TC1796

32-Bit Single-Chip Microcontroller

TC1796 Documentation Addendum**Revision History: V2.0 2008-04**

This document describes corrections, changes, and improvements for the two parts of the TC1796 User's Manual V2.0 2007-07, the System Units book (Volume 1) and the Peripheral Units book (Volume 2). These corrections will be considered with the next update of these User's Manual documents.

Figure 21-26 Receive Data Interrupt Control

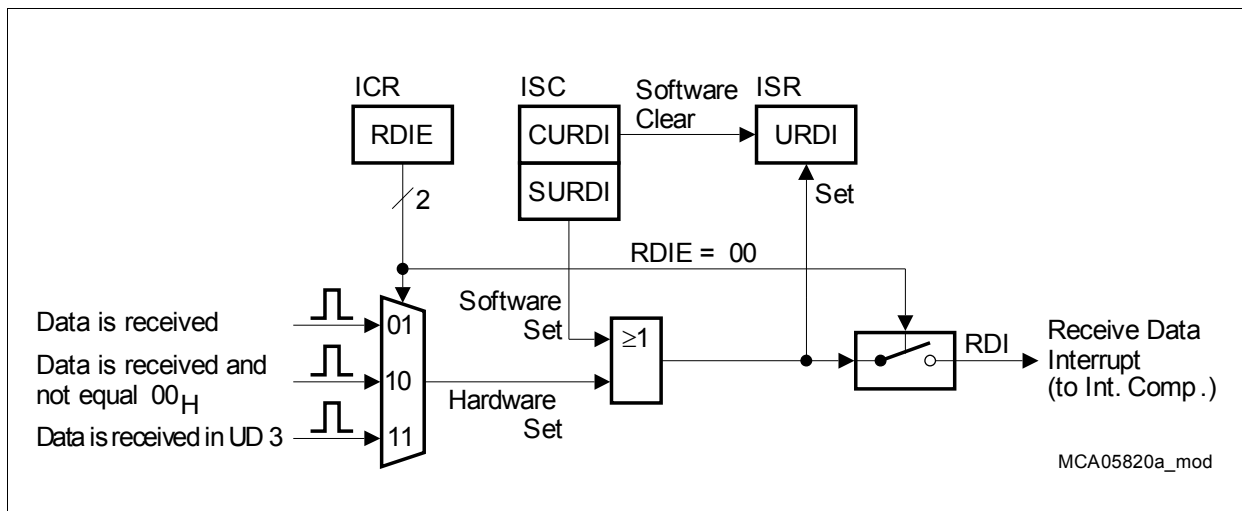
Page 21-34

In the paragraph above Figure 21-26 "ISC.SRDI and ISC.CRDI" must be changed into "ISC.SURDI and ISC.CURDI".

Figure 21-26 must be updated with the following figure (output signal on the right side):

Figure 24-86 Block Diagram of GPTA Implementation

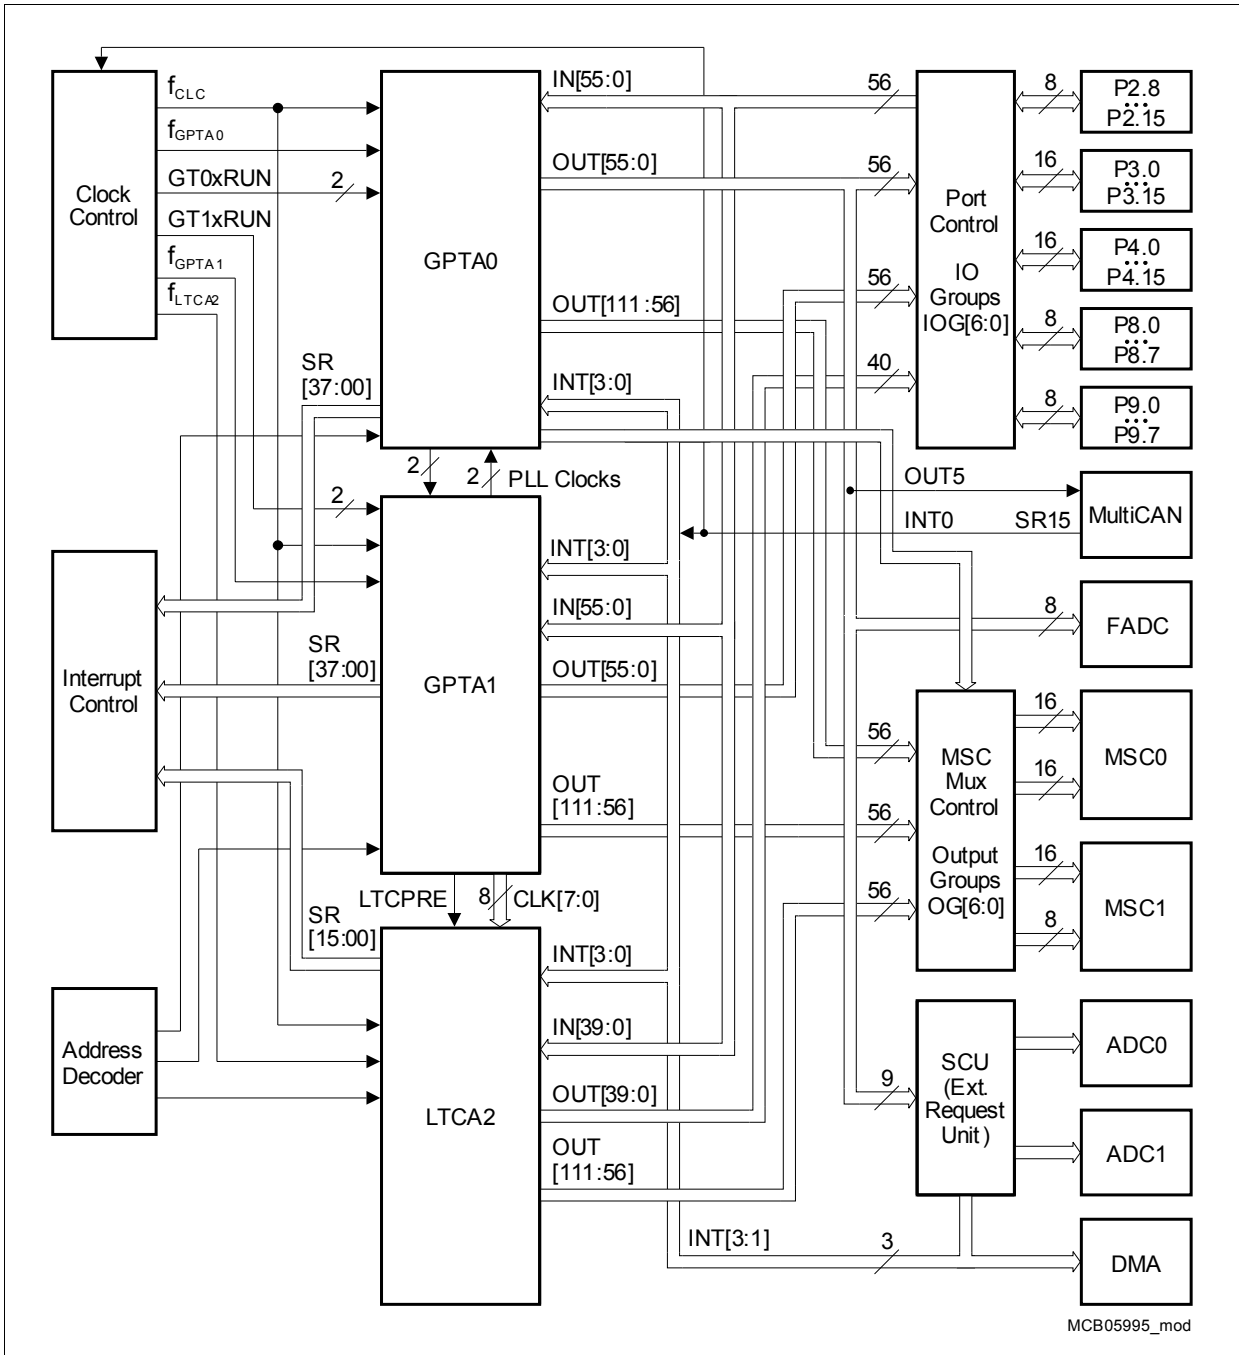
Page 24-248

Figure 24-86 must be updated with the following figure (LTCPRE input of LTCA2):
